**ADDENDUM NO. 1
TO
CONTRACT DOCUMENTS
FOR
CITY OF MANISTIQUE
MARINA RENOVATION PROJECT – PHASE II
JULY 9, 2018**

This addendum addresses two items: The Floating Pier Pre-bid Qualification Manufacturer to date, and the addition of a sidewalk support at the sheet pile wall. The sidewalk support affects Pay Item – Sidewalk, Conc, Modified, 4-Inch, and Pay Item – Sheet Pile Wall.

SIDEWALK AT SHEET PILE WALL DETAIL
NO SCALE

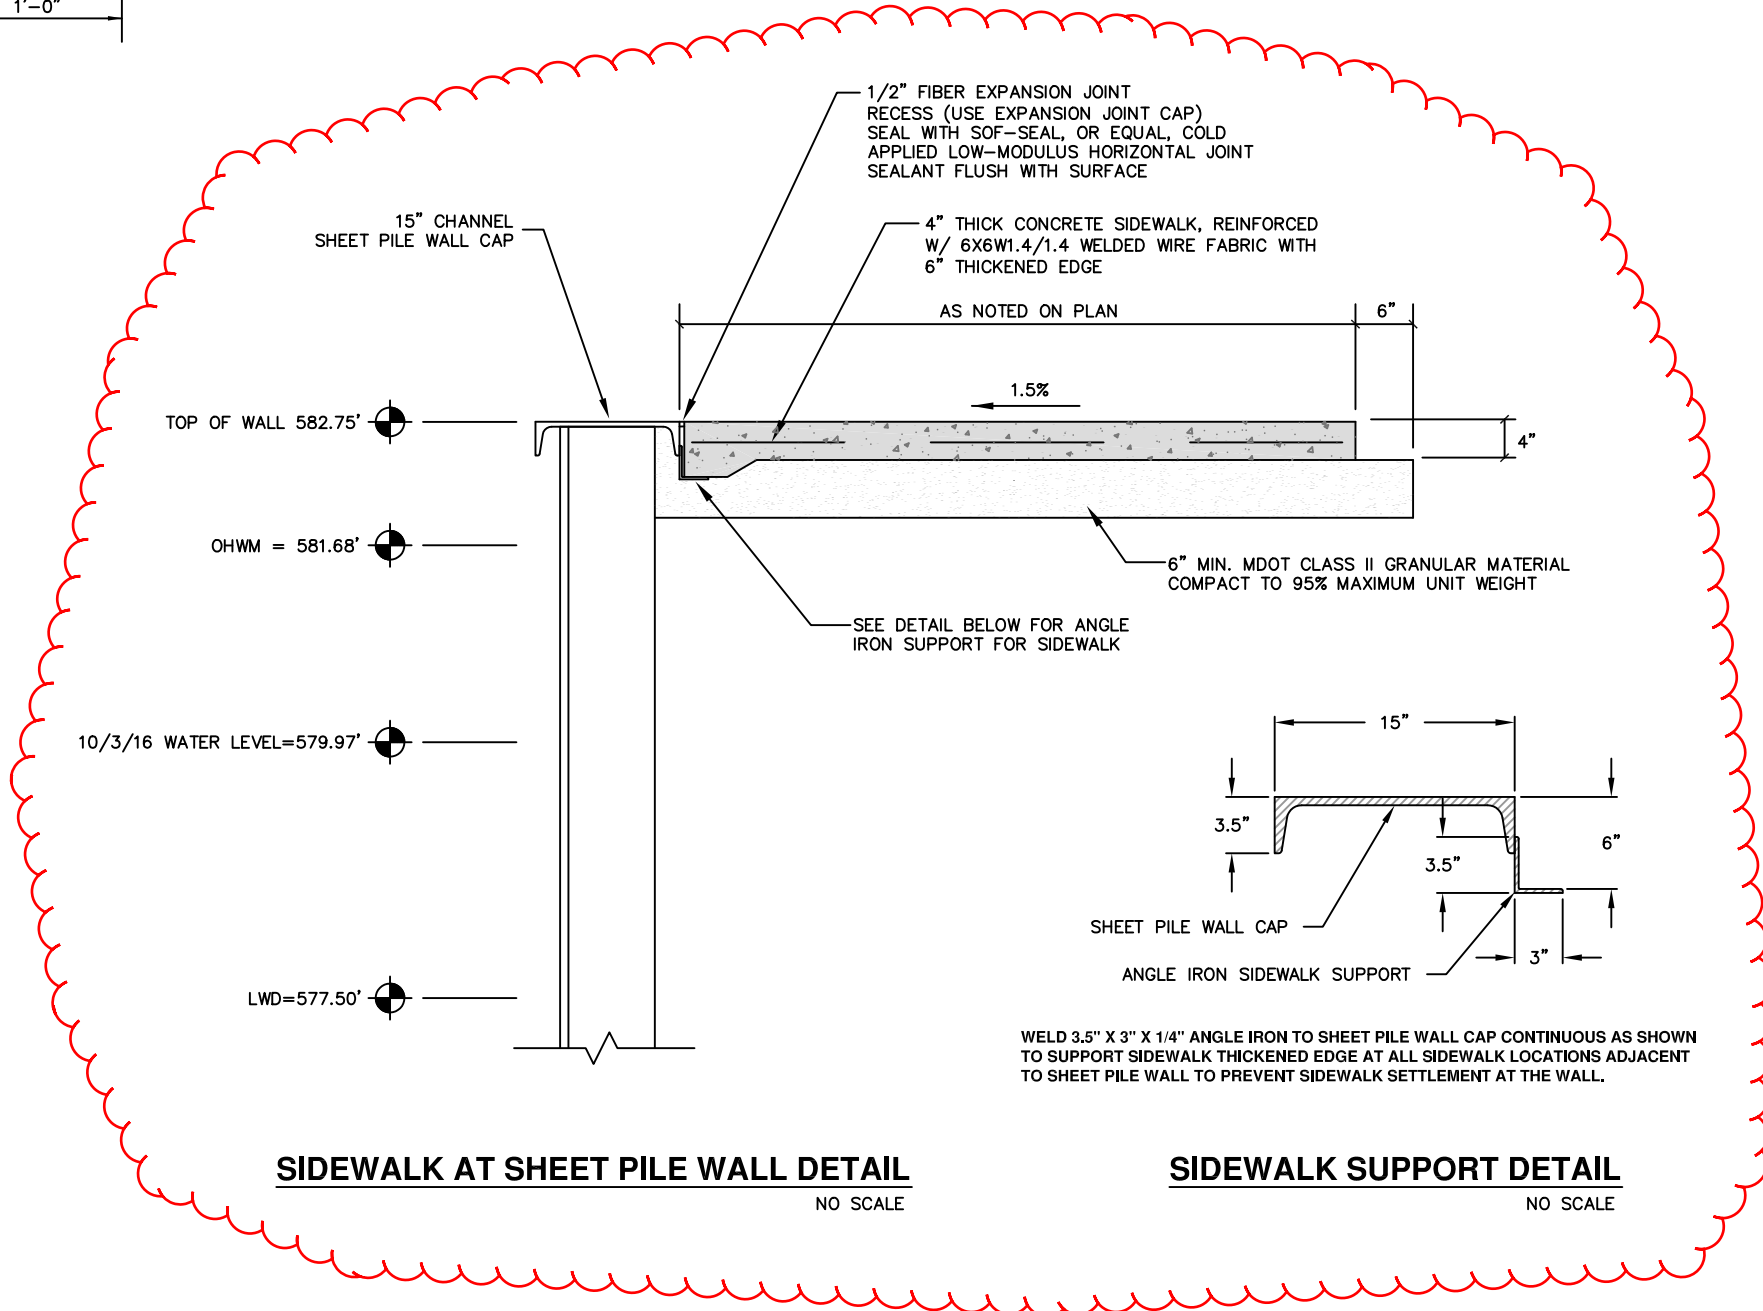
Item 13 has been modified to include the additional sidewalk thickened edge at the sidewalk support attachment to the sheet pile wall cap according to revised plan sheet No. 21 attached as part of this Addendum.

1. Plan Sheet 21 shall be replaced in its entirety with the attached sheet. Changes include modification of the “Sidewalk at Sheet Pile Wall Detail” to include sidewalk support and the addition of a “Sidewalk Support Detail”.
